CUMBERLAND COUNCIL DELEGATED PLANNING DECISION

1.	Reference No:	4/20/2309/0F1
2.	Proposed Development:	CONVERSION OF EXISTING BUILDING CONTAINING FLATS TO FORM FIVE DWELLINGS, MINOR EXTERNAL ALTERATIONS, DEMOLITION OF EXISTING SINGLE STOREY EXTENSION, THE CONSTRUCTION OF A NEW ACCESS AND ASSOCIATED CAR PARKING AREA

3.	Location:	HENSINGHAM HOUSE, EGREMONT ROAD, HENSINGHAM, WHITEHAVEN
4.	Parish:	Whitehaven
5.	Constraints:	ASC;Adverts - ASC;Adverts, Conservation Area - Conservation Area, Coal - Standing Advice - Data Subject To Change

- The wall in question is shown in the following photos

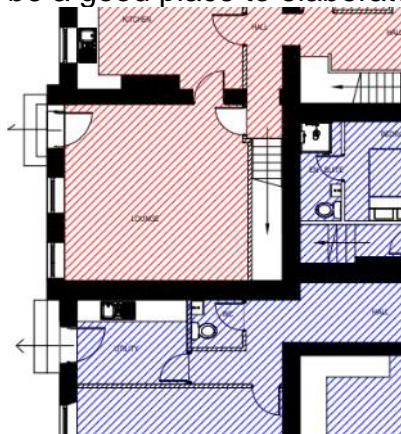
<p>the western façade could be found, preferably making use of a single central door in the projecting bay</p> <ul style="list-style-type: none"> ○ Confirmation of whether an alternate layout for House 1 can be used whereby the utility room and GF WC are relocated to the room adjacent to the central courtyard (assuming this would assist in removing servicing outlets and the door from the frontage) ○ Confirmation of whether the existing and proposed plans and elevations are drawn correctly, bearing in mind the abovementioned discrepancies, or revised drawings. ○ Detail added to the heritage statement showing that the proposed access location is the most justifiable of those considered, and justifying the need for the access to be big enough to admit a large dustbin lorry when this is not currently the case even with a higher number of properties. ○ A drawing for the entrance showing proposal to reuse existing walling/pier material, location of walls etc. ○ Detail added to the heritage statement demonstrating that the existing access lane (even within the site only, which might be picked up by an improved entrance) and the existing parking areas are unsuitable for reuse and adaptation to the needs of the reconfigured building. ○ Existing and proposed site plans showing existing access/parking features in relation to how they will be reconfigured. The applicants/agent should check which trees if any will require serving notification to the Council. ○ I request a condition be added to any approval decision requiring details of the extent and nature of render removal and replacement to be submitted and approved prior to re-rendering work taking place. ○ I request a condition be added to any approval decision requiring details of replacement windows and external doors to be submitted and approved prior to replacement of any windows and external doors. ○ I request a note be added to the heritage statement confirming the commitment to retain the existing Georgian front door of Hensingham House, in the south side porch. ○ I would be grateful to the applicant/agent for an update on the status of upper floor ceilings once the 1960s dropped ceilings are removed as it is likely more conservation advice may be needed then, and also to provide a record for the planning history. <p>1st July 2022</p> <ul style="list-style-type: none"> • Permission would appear to be needed for demolition of the wall at

the north side of the rear of the site (where House 3's garden and turning area are located on the proposed block plan) as this is over 2m in height and within a conservation area.

<p>appearance of the conservation area, and to the settings of nearby heritage assets.</p> <ul style="list-style-type: none"> • Given the modest significance of the wall and the small contribution it makes to the conservation area, and given its poor condition and extensive repair needs, which would probably include substantial rebuilding, removal of this section would appear justified. • This does not apply to the wall curved brick faced section of wall nearer the house, which has already been discussed. <p>Please refer to my previous consultation response for other awaited forms of information.</p> <p>30th March 2023</p> <ul style="list-style-type: none"> • A plan has been received showing detail of the revised drive entranceway. • The revised entrance is considerably wider than the existing entrance, however the removal of a garage that makes a negative contribution to the conservation area as well as settings of nearby heritage assets, principally the grade II listed war memorial, is beneficial. • Currently, the impression is of stone walls with gate piers giving way to clipped hedging beyond, lining the drive. • The profile of the wall and gate pier on the north side appears to be staying the same, but I would request the wall on the south side be rebuilt on the new profile, with the gate pier reinstated to match. • 2m high fencing is proposed on the north side beyond the wall, where there is currently a tall clipped hedge. This is likely to be less attractive and could be considered loss of an element that makes a positive contribution to a conservation area, which would be treated as less-than-substantial harm to a designated heritage asset, as well as to the setting of the war memorial. • As the north side of the access drive is staying on the same profile, it should be possible to retain the existing hedge, or to instate a new hedge if needed, and this would be preferable. <p>Please refer to my previous consultation response for other awaited forms of information.</p> <p>12th April 2023</p> <ul style="list-style-type: none"> • A revised site entrance plan has been received showing detail of the revised drive entranceway. <ul style="list-style-type: none"> ○ The annotations have been revised to clarify that the wall on the south side will be re-built along the new profile, and that the boundary on the north side will be a stone wall to match
